Strathcona Gardens Rec-Reate Aquatic Centre & Renovations **ADDENDUM #4**

Date: March 28, 2024

ARCHITECTURAL TENDER ADDENDUM #4

This addendum revises the Tender Documents for Strathcona Gardens REC-REATE issued for tender February 2, 2024.

Sheet title
SCHEMATICS - HVAC

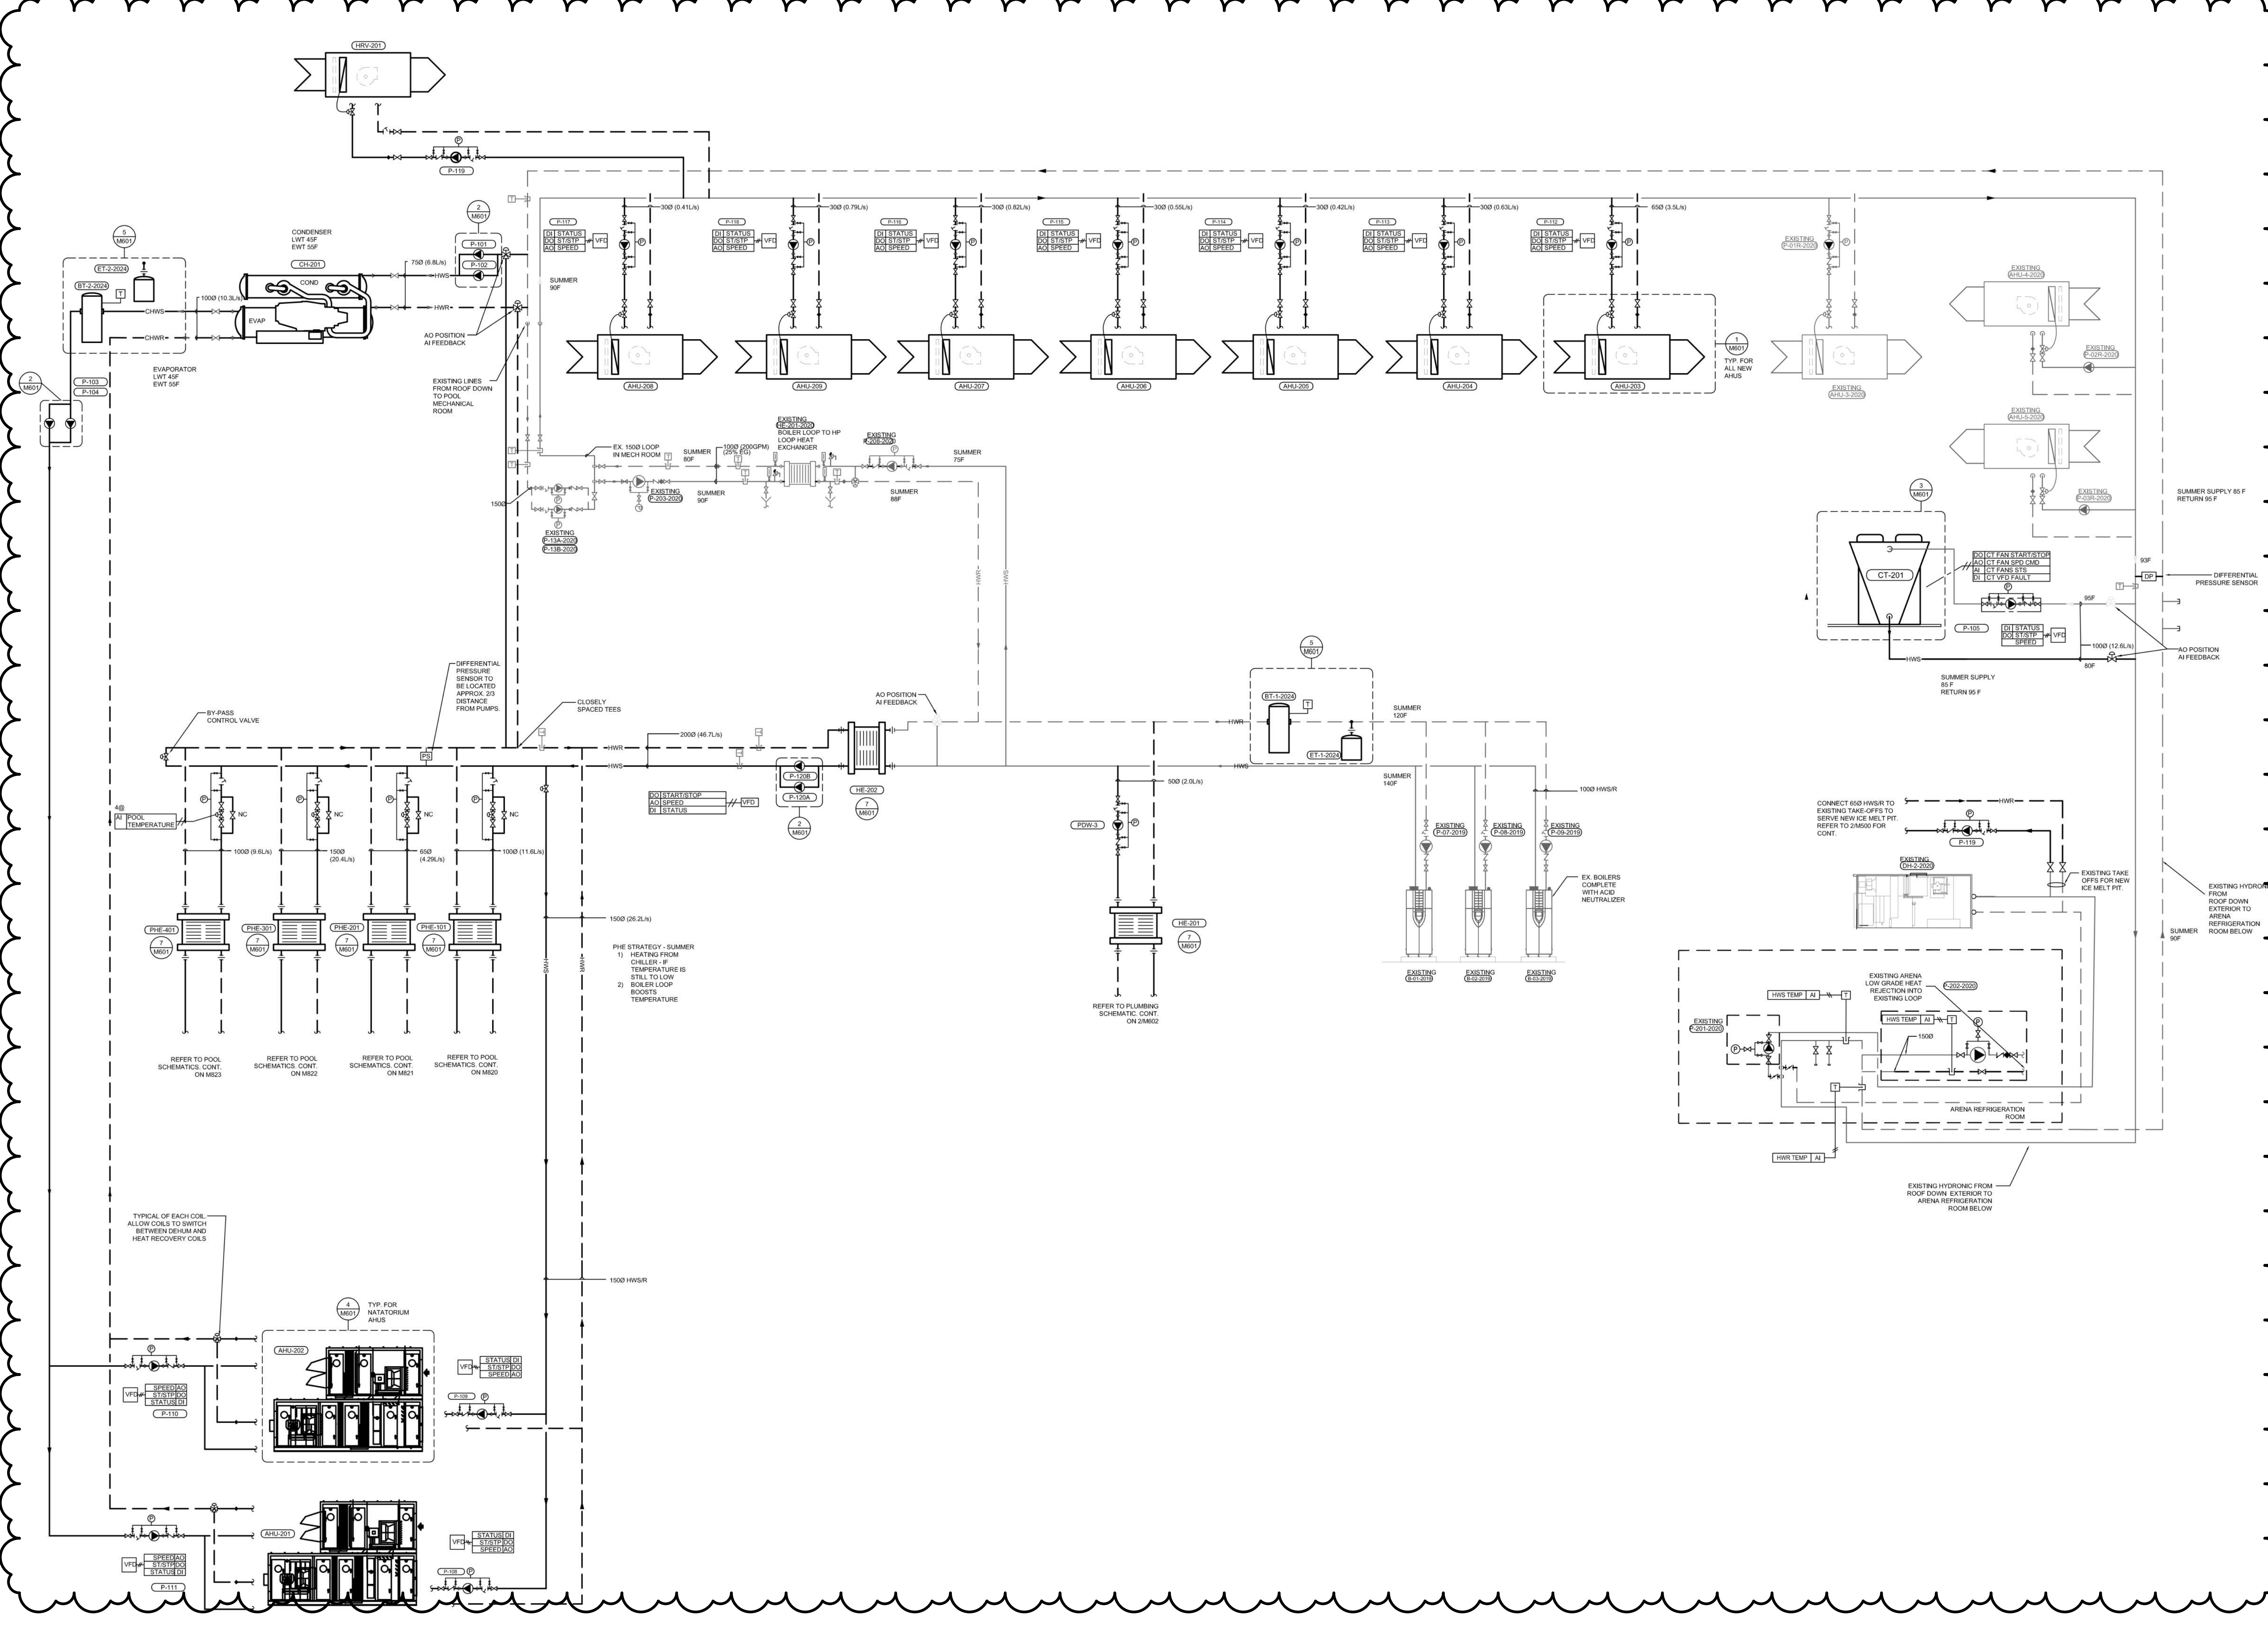
- .1 Revise:
 - .1 Refer to attached Hydronic schematic for revisions.
